HISTORIC AND DESIGN REVIEW COMMISSION

May 06, 2015

HDRC CASE NO: 2015-161
ADDRESS: 106 W ROSEWOOD AVE
LEGAL DESCRIPTION: NCB 6458 BLK 9 LOT 74 AND 75 76
ZONING: R5 H
CITY COUNCIL DIST.: 1
DISTRICT: Monte Vista Historic District
APPLICANT: Mike Carte
OWNER: Dennis Ahlburg
TYPE OF WORK: Exterior alterations to existing garage
REQUEST:

VIEW FROM ALLEY

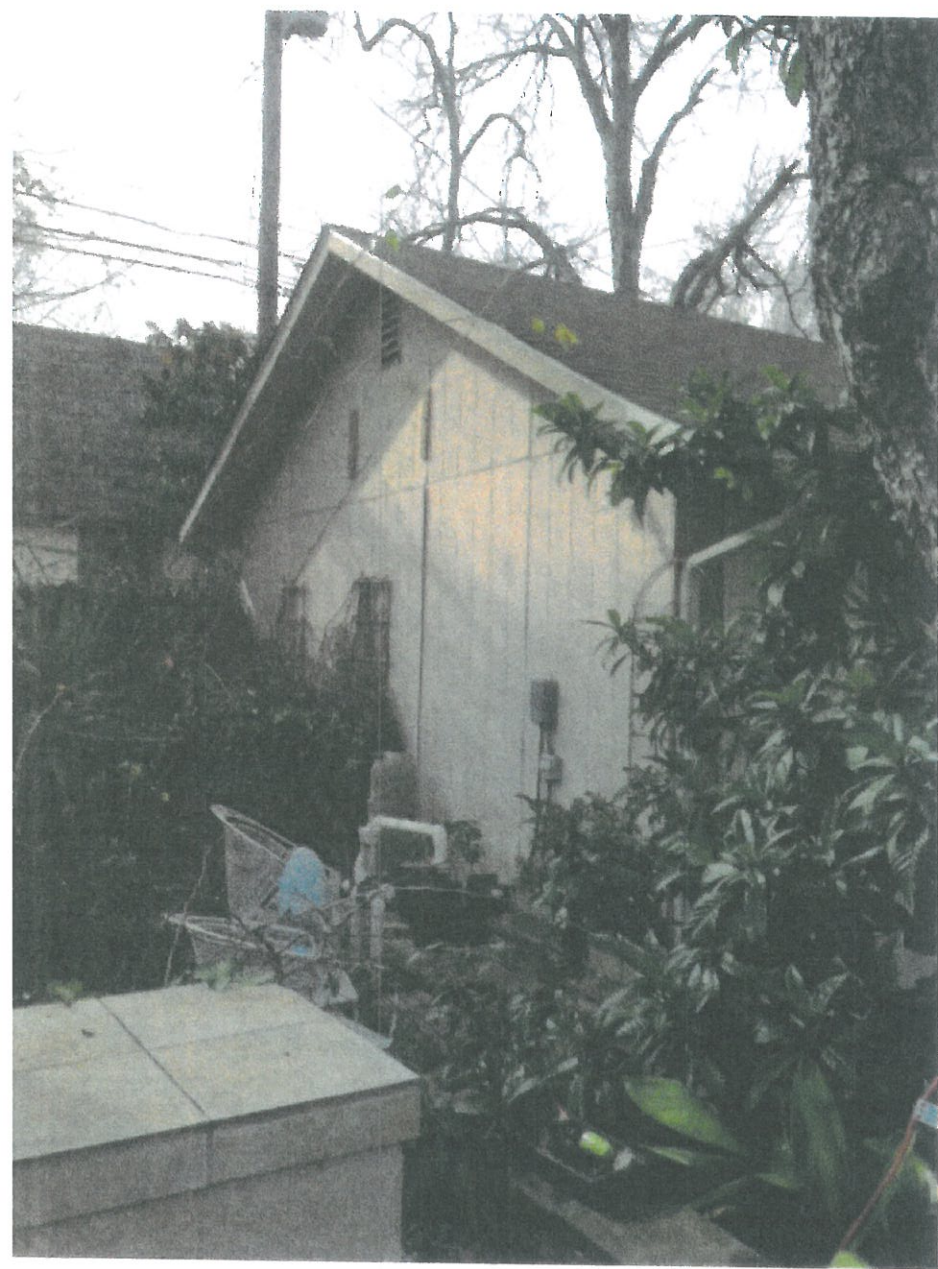
Replace
Siding
on
this
wall
w/
T 111
Pine
4x8
siding
(paint to
match).

Add new
window
& replace
existing
window
w/ dbl.
pine lower
aluminum
frame
windows

Replace rotted fascia
wood as needed w/ 1x pine
(paint to match)

Staff recommends approval of item 1 and 2 based on findings a-c with the stipulation that the new windows are one over one without any false divisions.

FRONT ELEVATION (Left side)

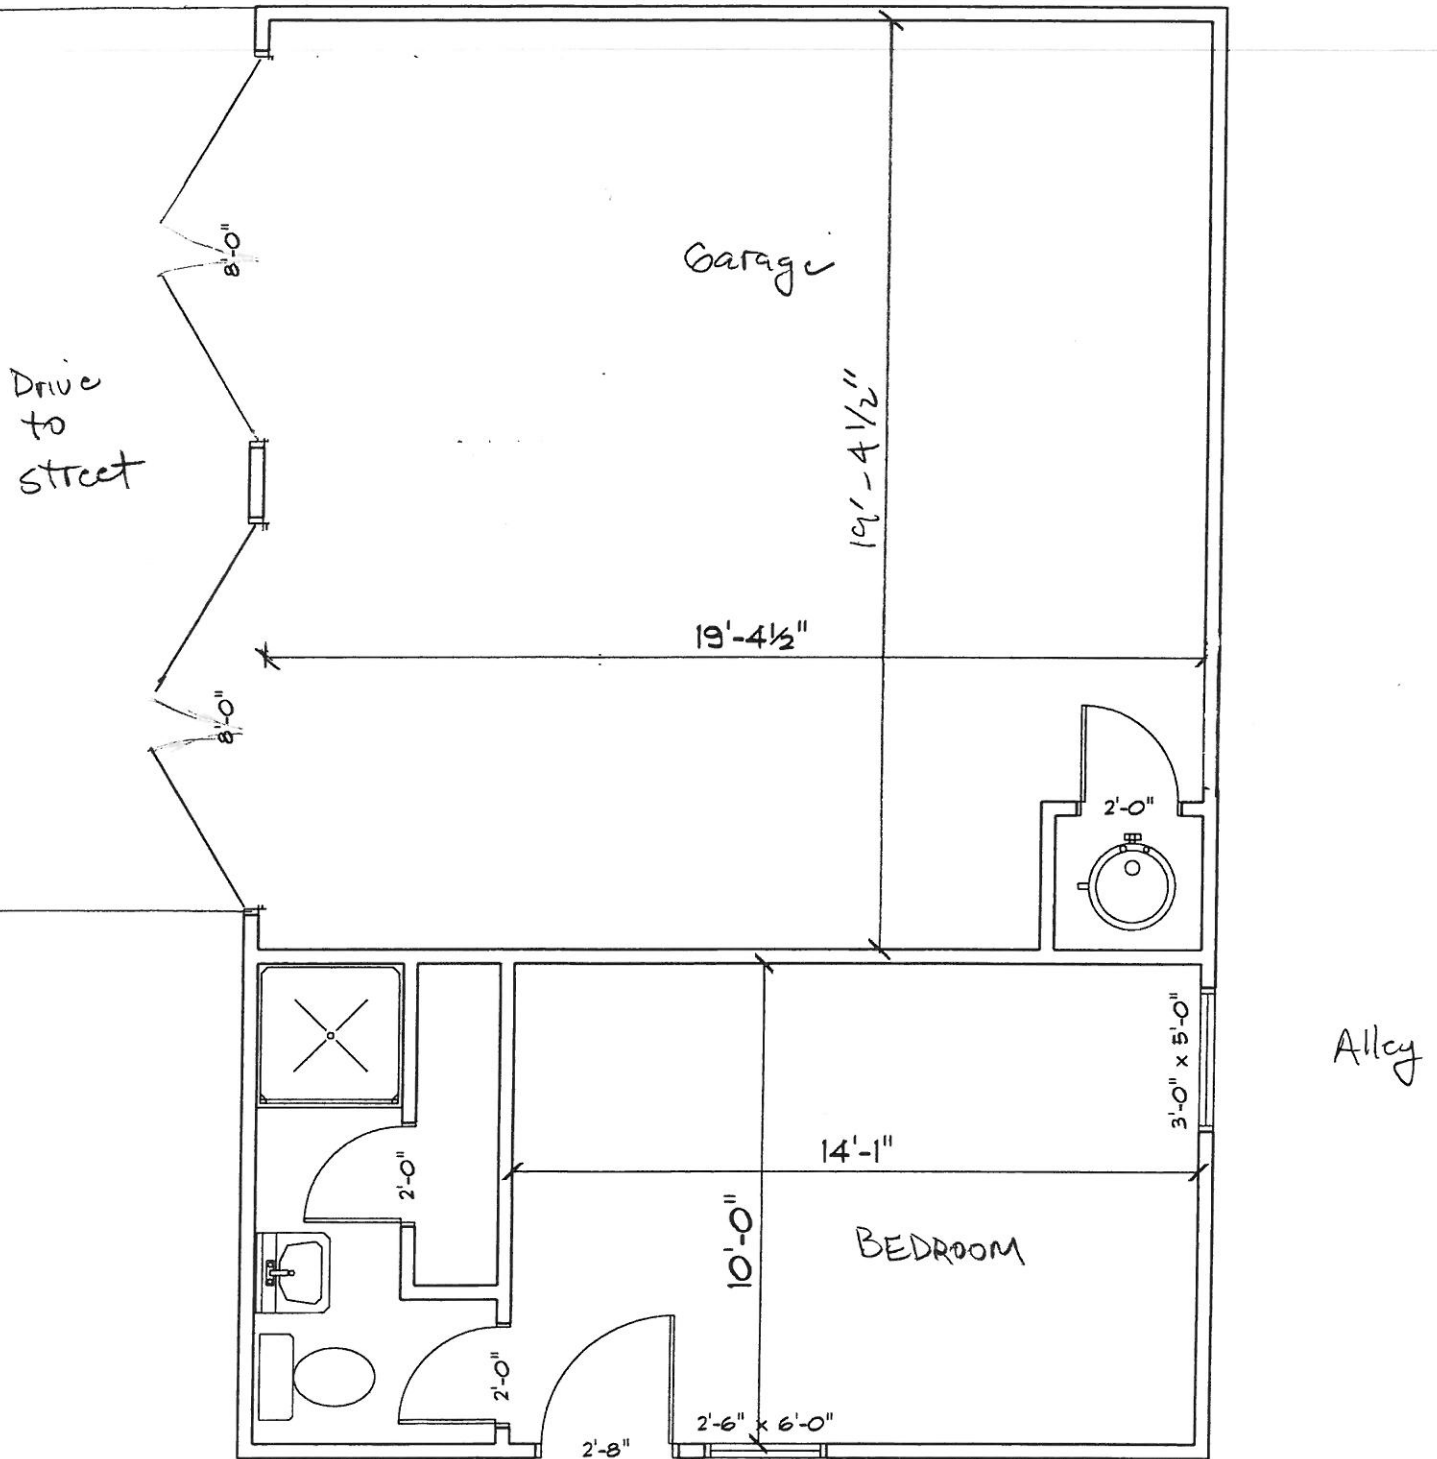
ADD
12
LT
Entry
Door
Here
Behind
existing
wood
double
doors
(leave
double
doors
in place).

No change to these elevations.

PROPOSED PLAN

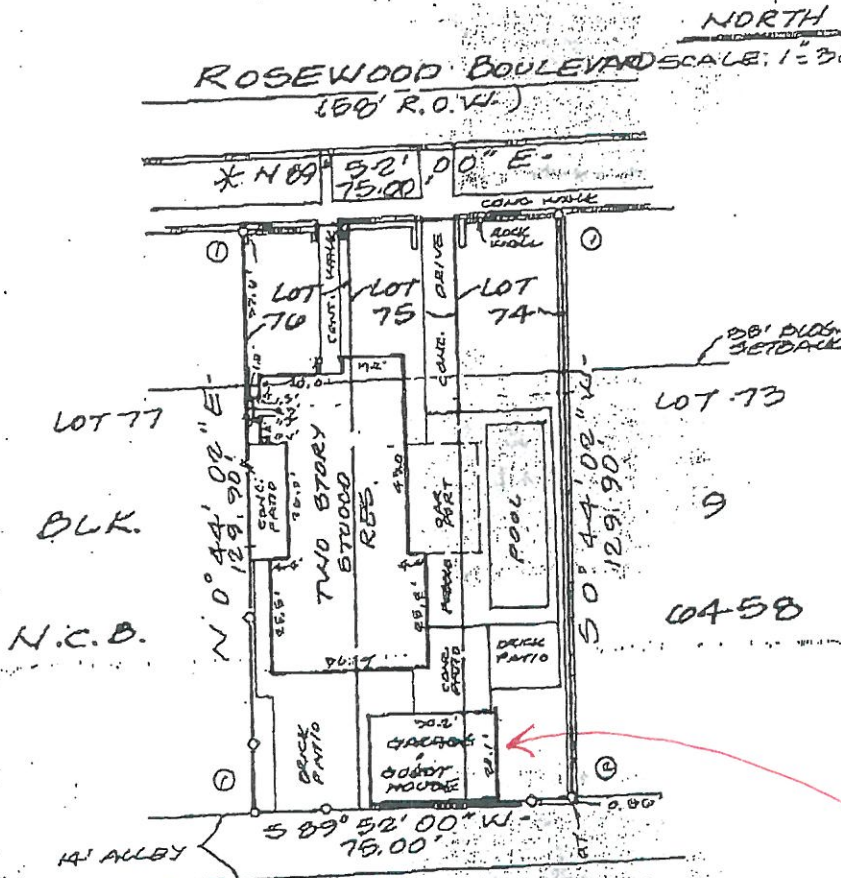
Remove
existing
rotted
siding
&
install
new
T-111
pine
4'x8'
siding
this
ext
wall
